**Environmental Investigation
Plan
Kingston Fossil Plant**

Revision 4

TDEC Commissioner's Order:
Environmental Investigation Plan
Kingston Fossil Plant
Harriman, Tennessee

| Revision | Description | Date |
|-----------------|--|--------------------|
| 1 | Addresses June 22, 2017 TDEC Review Comments and Issued for TDEC Review | September 8, 2017 |

Exhibit No.
2

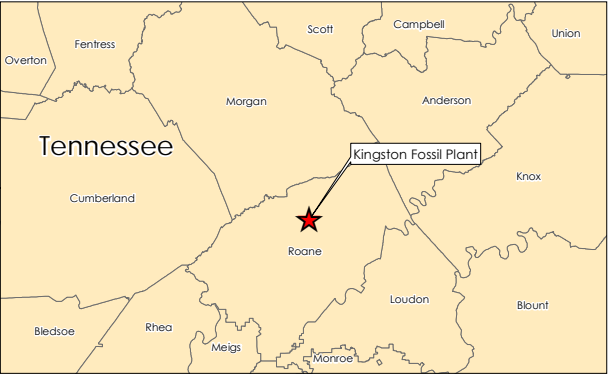
| Comment Number | Section Number | Section Title | Page | Paragraph | Line | TDEC Comment (December 8, 2017) | TVA Response (March 2, 2018) |
|----------------|----------------|----------------------------------|------|-----------|------|---|--|
| 25 | 3.1.2 | TDEC Site Specific Request No. 2 | 12 | 3 | 3 | Based on exhibit #2 it appears that near the ballfield and sluice trench there are only 2 downgradient monitoring wells. At a minimum there should be three downgradient wells. TDEC would like TVA to evaluate potentially placing the third downgradient well southeast of AD-2. | A third monitoring well downgradient of the ballfield and sluice trench and northeast of well AD-2 has been added to the proposed monitoring well network for the investigation as shown on Exhibit No. 2. Monitoring well installation and sampling procedures for the additional well are included in the updated Hydrogeological Investigation and Groundwater Investigation SAPs, respectively. |

| Comment Number | Section Number | Section Title | Page | Paragraph | Line | TDEC Comment (December 8, 2017) | TVA Response (March 2, 2018) | TDEC Comment (May 4, 2018) |
|----------------|-------------------------|--|------|-----------|------|---|--|--|
| 39 | 3.5.1 | GW -Chem Properties | 23 | 2 | 7 | The replacement well location for MW KIF-22 must be authorized by TDEC's CCR Technical team before placement. TDEC's authorization shall include any other wells placed under this BP. Are the proposed location identified in Appendix D still accurate? | Comment acknowledged. The location of new well 22C is included in Appendix D. Proposed monitoring well locations in Appendix D are still accurate. | There is no well 22C depicted on Exhibit 2 |

| Comment Number | Section Number | Section Title | Page | Paragraph | Line | TDEC Comment (December 8, 2017) | TVA Response (March 2, 2018) | TDEC Comment (May 4, 2018) | TVA Response (June 15, 2018) |
|----------------|----------------|----------------------------------|------|-----------|------|--|--|---|--|
| 25 | 3.1.2 | TDEC Site Specific Request No. 2 | 12 | 3 | 3 | Based on exhibit #2 it appears that near the ballfield and sluice trench there are only 2 downgradient monitoring wells. At a minimum there should be three downgradient wells. TDEC would like TVA to evaluate potentially placing the third downgradient well southeast of AD-2. | A third monitoring well downgradient of the ballfield and sluice trench and northeast of well AD-2 has been added to the proposed monitoring well network for the investigation as shown on Exhibit No. 2. Monitoring well installation and sampling procedures for the additional well are included in the updated Hydrogeological Investigation and Groundwater Investigation SAPs, respectively. | TDEC requested a well to the southeast of AD-2, TVA shall install the requested well. TVA has agreed to conduct an environmental investigation at the TVA KIF as required in the Commissioner's Order it received and did not appeal. It is TVA's responsibility to submit an Environmental Investigation Plan for TDEC's review and make changes to the EIP as requested by TDEC. When there are questions concerning any part of the EIP, TVA should discuss their concerns with TDEC and TDEC shall consider TVA's concerns. However, if TDEC and TVA disagree on any matter, TVA shall perform investigative activities as specified by TDEC. | After receiving additional clarification from TDEC, one monitoring well will be installed southwest of AD-2 in the unconsolidated materials above bedrock to satisfy this request. |

| Comment Number | Section Number | Section Title | Page | Paragraph | Line | TDEC Comment (December 8, 2017) | TVA Response (March 2, 2018) | TDEC Comment (May 4, 2018) | TVA Response (June 15, 2018) |
|----------------|----------------|--|------|-----------|------|---|--|---|--|
| 39 | 3.5.1 | GW -Chem Properties | 23 | 2 | 7 | The replacement well location for MW KIF-22 must be authorized by TDEC's CCR Technical team before placement. TDEC's authorization shall include any other wells placed under this EIP. Are the proposed location identified in Appendix D still accurate? | Comment acknowledged. The location of new well 22C is included in Appendix D. Proposed monitoring well locations in Appendix D are still accurate. | There is no well 22C depicted on Exhibit 2 | Well 22C has been added to Exhibit 2. |

Exhibit No.
3

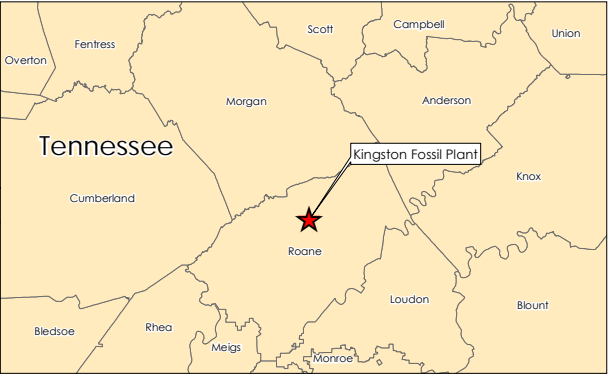
| Section Number | Section Title | Page | Paragraph | Line | Comment |
|-------------------------|---|------|-----------|------|--|
| Appendix D | Exhibit 3 | 232 | All | All | Wells 27A, 27B, 22, And 22B should be added to the Study Area monitoring network. |

| Comment Number | Section Number | Section Title | Page | Paragraph | Line | TDEC Comment (December 8, 2017) | TVA Response (March 2, 2018) |
|----------------|-----------------------------|---|------|-----------|------|--|--|
| 74 | Appendix D | Exhibit 3 | 232 | All | All | Wells 27A, 27B, 22, And 22B should be added to the Study Area monitoring network. | See response to comment 28. |

| Comment Number | Section Number | Section Title | Page | Paragraph | Line | TDEC Comment (December 8, 2017) | TVA Response (March 2, 2018) | TDEC Comment (May 4, 2018) | TVA Response (June 15, 2018) |
|----------------|----------------|------------------------------|------|-----------|------|--|--|---|--|
| 74 | Appendix D | Exhibit 3 | 232 | All | All | Wells 27A, 27B, 22, And 22B should be added to the Study Area monitoring network. | See response to comment 28. | See response to comment 28. | In TVA's response to TDEC's initial comment, TVA agreed to use data from monitoring wells that are part of other regulatory programs in the EAR. TVA defined the term "Study Area" to collectively describe the CCR units included in the Order. |
